Eliminate Limit Switches

TIP Z022A-0003

All Splicers with mechanical limit switches.

Eliminate Limit Switches

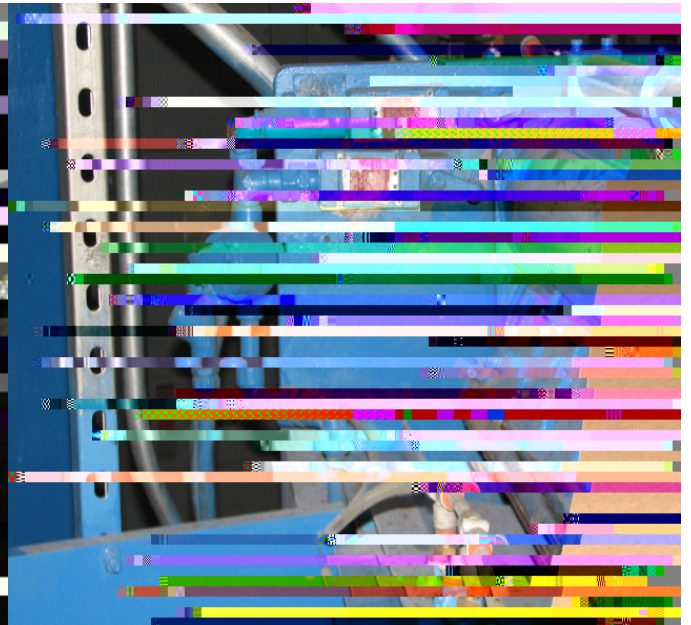
- This improvement replaces the original mechanical limit switches with proximity switches

This improvement replaces the existing mechanical limit switches with proximity switches. This eliminated the constant re-adjustment the is required to the mechanical switches over time due to the severe duty they endure.
